SUBJECT: Waterford SES Unit 3  
Docket No. 50-382  
Removable Section in South Wall of Diesel Generator 3BS Room

The purpose of this letter is to inform you of the installation of a removable section in the south wall of the 3BS Diesel Generator Room (Note Attachment 1, Figure X-5 showing the subject wall separating RAB 15 and RAB 23). This subject was previously discussed with Mr. D. Kubicki, of the NRC staff, during a telephone conversation on September 14, 1983 with LP&L's Mr. E. Senac.

FIGURE X-5

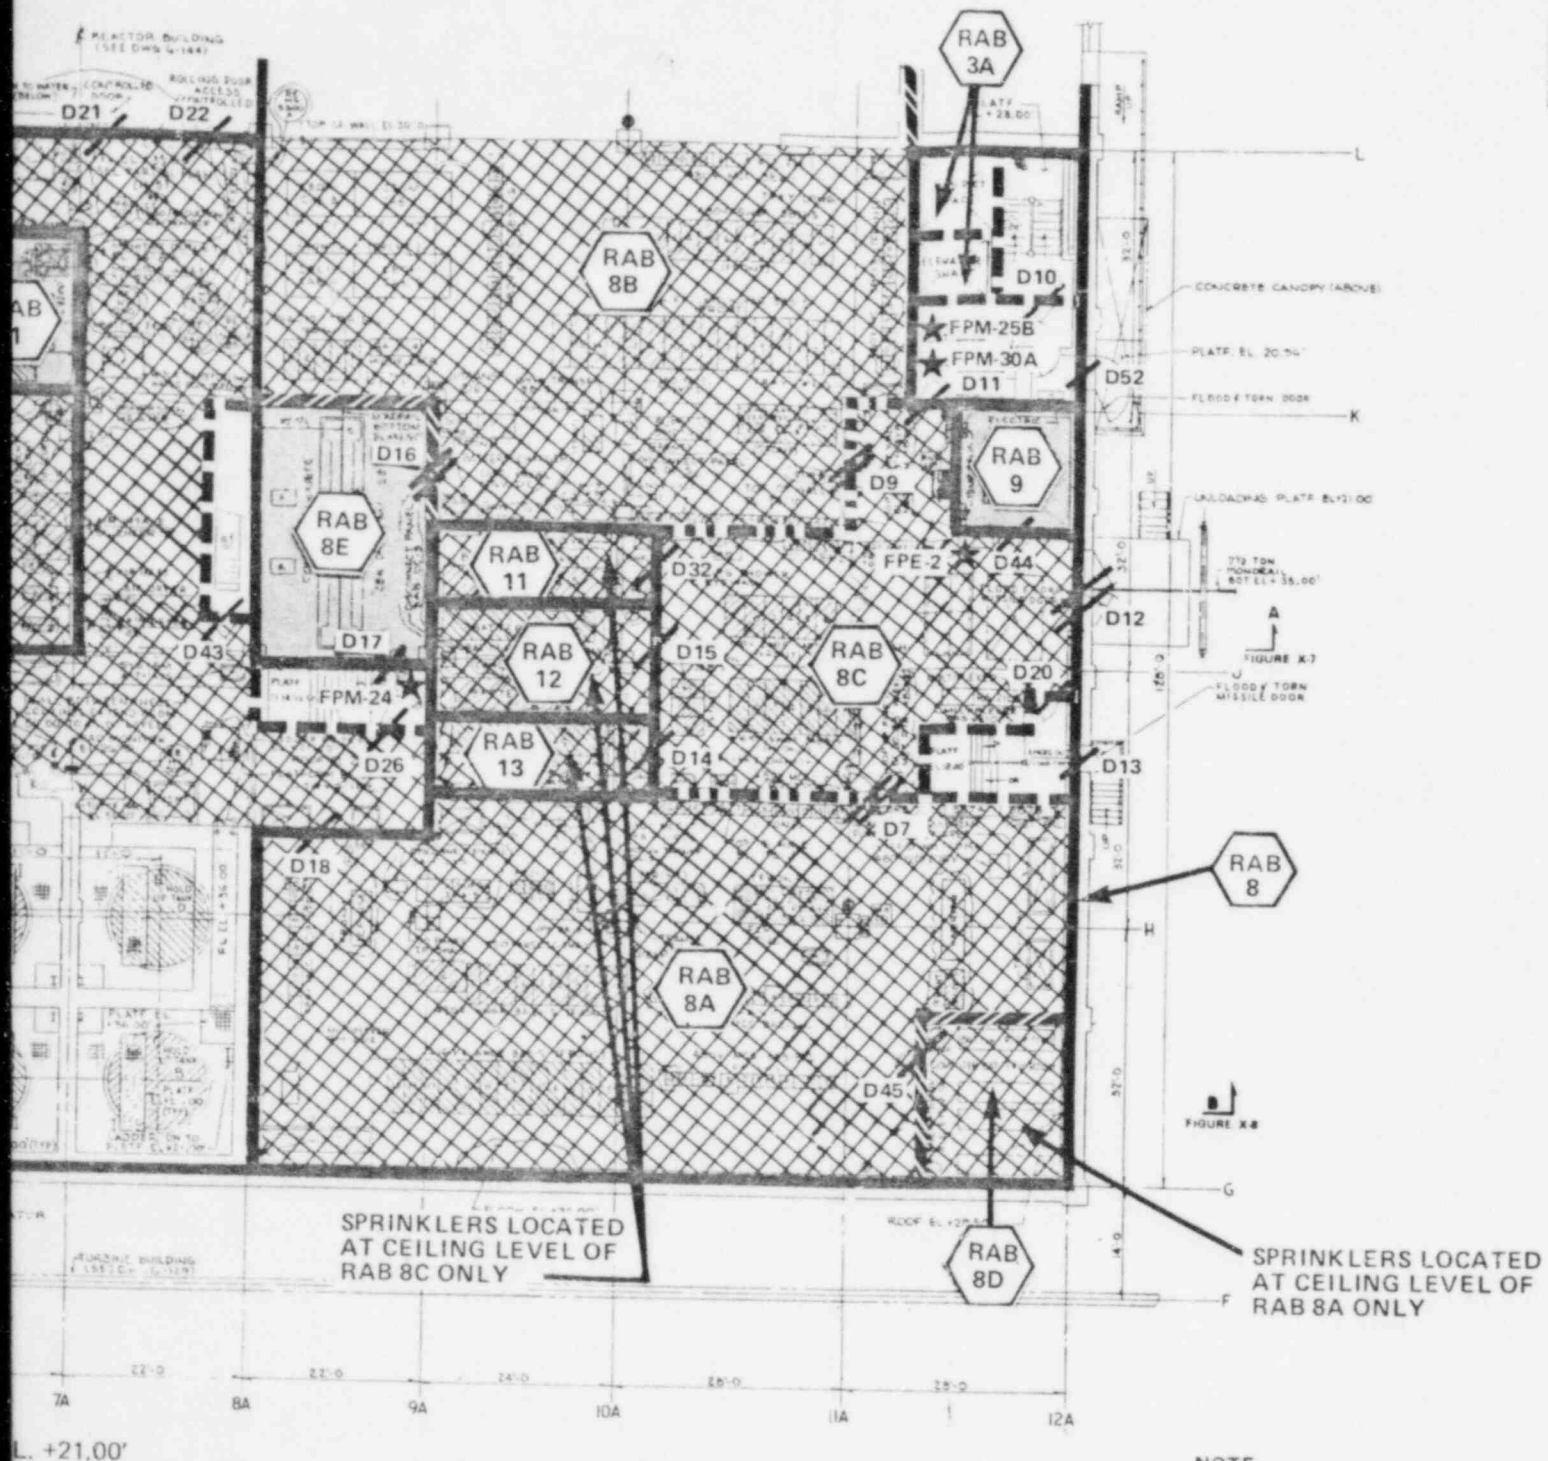
This arrangement is a change from that currently described in the FSAR, which states that the two fire areas interfacing at this wall (RAB 15/3BS-EDG Room and RAB 23/Corridor Area and Common Passageway) are separated by a three hour barrier. As construction proceeded it was apparent to LP&L that it was essential for the subject wall to be removable in order to allow maintainability of the 3BS EDG. The removal of the 30' x 19' section will provide access for the passage of maintenance equipment and large parts associated with the diesel.

FOR APPROVAL	DESCRIPTION OF ISSUE	CHK. APPD.	RH	JOB # 40-2696	INDUSTRIAL ACOUSTICS COMPANY, INC. 1160 COMMERCE AVENUE BRONX, N.Y. 10462	DWG B-8215-358-2	ISSUE A
--------------	----------------------	------------	----	------------------	--	---------------------	------------

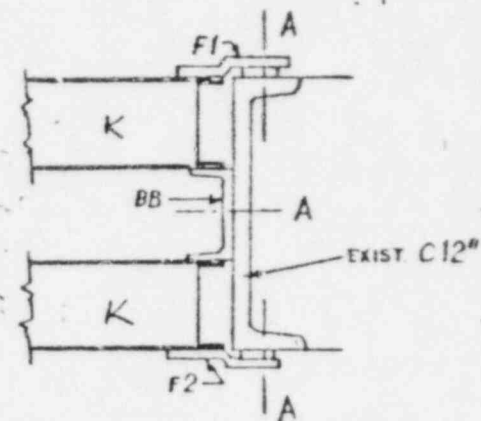
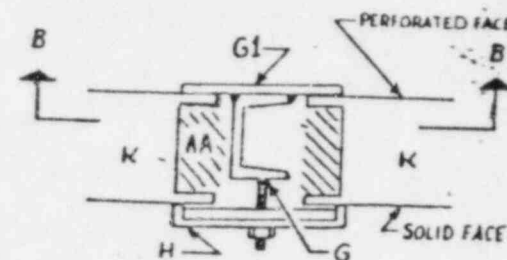
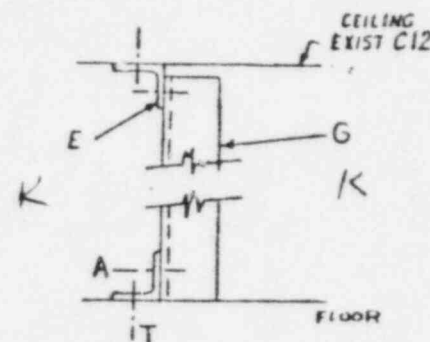
→ 30' 0" (as built).

Adjust to match

CROSS SECTION OF  
FIRE-NOISE-LOCK® PANEL

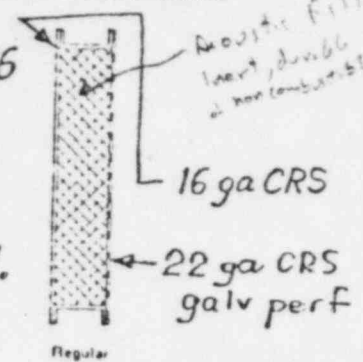
*Note*  
 All exposed steel sections shall be sprayed w/ fireproofing mtl to give you 3 hours rating requirement (except K and V)

*all should be labeled or in the field*

*Insulate H-Joiner - 20 ga CRS - Prime Painted*
